# HISTORIC AND DESIGN REVIEW COMMISSION

December 06, 2017

**HDRC CASE NO:** 2017-544  
**ADDRESS:** 313 E LOCUST  
**LEGAL DESCRIPTION:** NCB 1738 BLK 3 LOT 3, EXC W 2 FT OF S 116.7 FT  
**ZONING:** C-2 H  
**CITY COUNCIL DIST.:** 1  
**DISTRICT:** Tobin Hill Historic District  
**APPLICANT:** Robert Moritz/DHR Architects  
**OWNER:** GCM Holdings, Inc.  
**TYPE OF WORK:** Construction of two, 2-story duplexes  
**APPLICATION RECEIVED:** October 17, 2017  
**60-DAY REVIEW:** December 16, 2017

The applicant is requesting conceptual approval to construct two, 2-story duplex structures on the vacant lot located at 313 E Locust.

# SETBACK EVALUATION

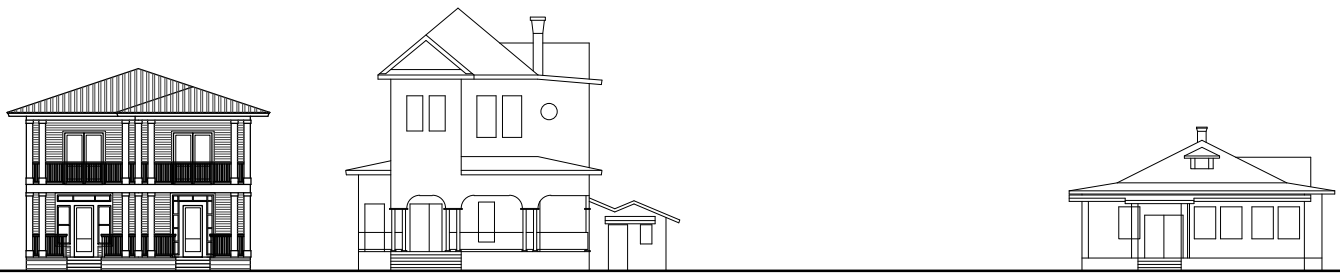
- e. **SETBACKS** – According to the Guidelines for New Construction, the front facades of new buildings are to align with front facades of adjacent buildings where a consistent setback has been established along the street frontage. This block of E Locust contains historic structures that feature front yard setbacks of approximately 20-35 feet. Based on the submitted documentation, the neighboring historic structure to the east has a front setback of 32.11 feet. The historic 1-story structure two lots down has a setback of approximately 18.24 feet. The applicant has proposed a setback of 28.27 feet. While the proposed setback is deeper than the median between the two of the historic structures that exist on the same block of E Locust, its placement would be approximately 3.84 feet closer to the sidewalk than the historic structure immediately adjacent to the east. Staff finds that the setback should be increased to be compatible with the historic structure immediately adjacent to the lot.

- i. That the applicant explores ways to increase the setback of the front unit to be more consistent with the adjacent 2-story historic structure as noted in finding e.
- ii. That the applicant modifies the proposed entryway configurations to be more consistent with transoms and side lites found on historic precedents in the district as noted in finding j.
- iii. That the applicant installs one-over-one wood windows or aluminum clad wood windows as noted in finding k. Meeting rails must be no taller than 1.25" and stiles no wider than 2.25". White manufacturer's color is not

SHEET TITLE  
 SITE PLAN/OVERALL STREET ELEV.

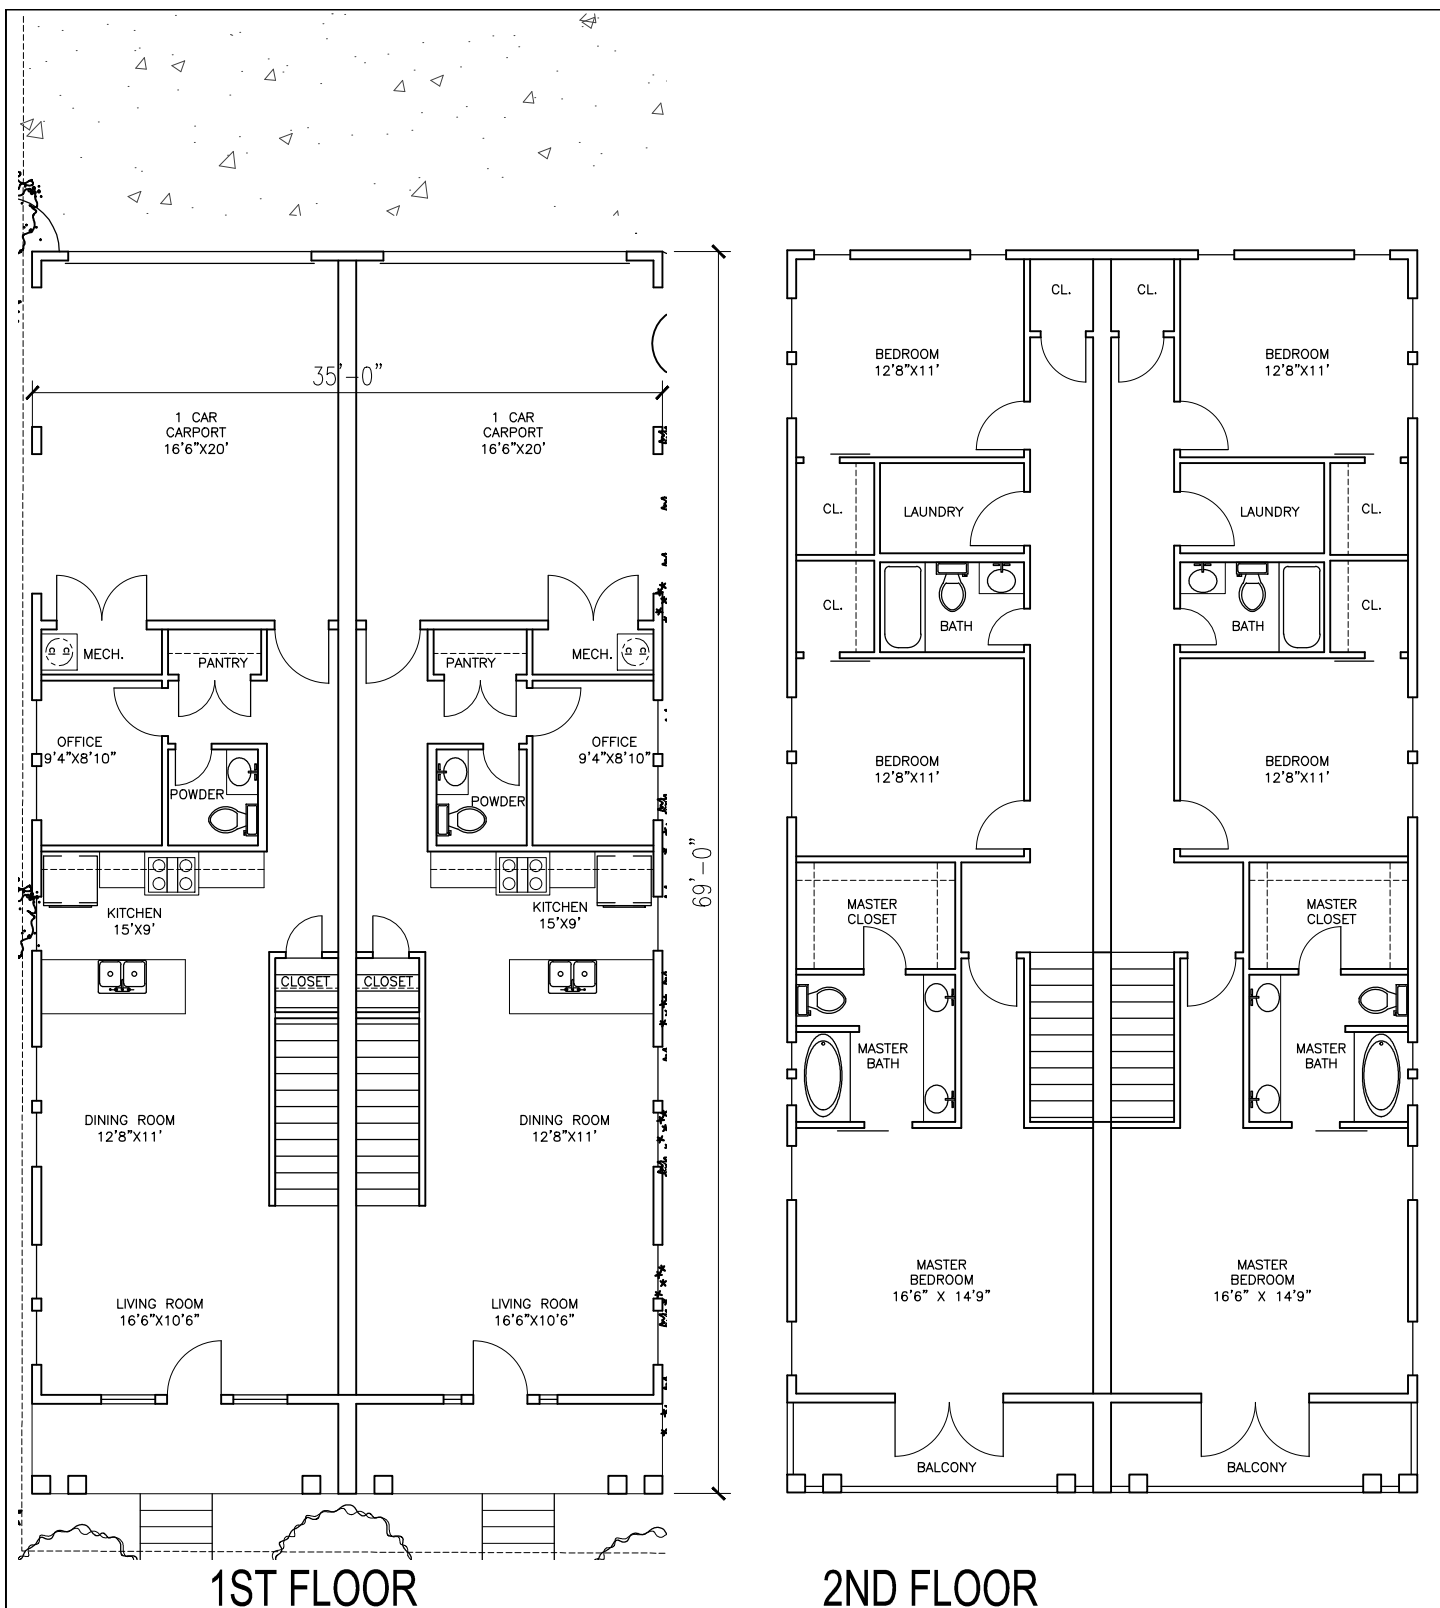
- l. **LOT COVERAGE** – New construction should be consistent with adjacent historic buildings in terms of the building to lot ratio. The building footprint for new construction should be no more than fifty (50) percent of the size of total lot area. The applicant has proposed to locate two units – one with a footprint of 2,415 square feet and one with a footprint of 1,230 square feet – on a lot featuring approximately 9,130 square feet. The proposed lot coverage is approximately 40%, which is generally consistent with the Guidelines.

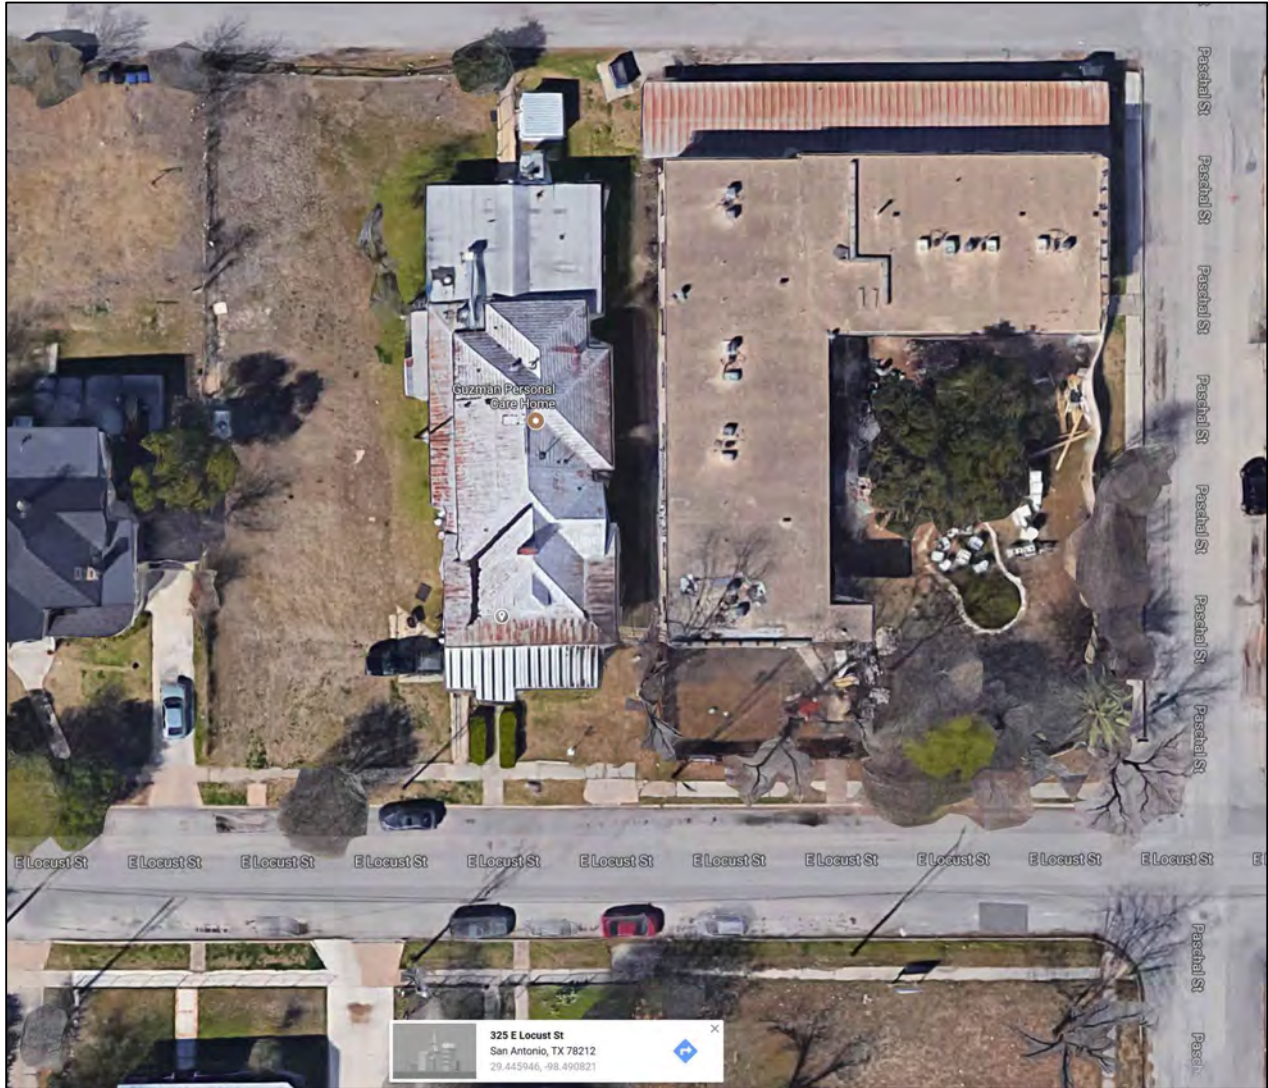
- m. **MATERIALS** – The applicant has proposed materials that include composite wood siding, standing seam metal roofs, and simple wood columns and railings. Staff finds siding and roofing materials to be generally consistent with the Guidelines and compatible for new construction in the district. Staff finds that the siding should feature a smooth finish and an exposure of four inches.
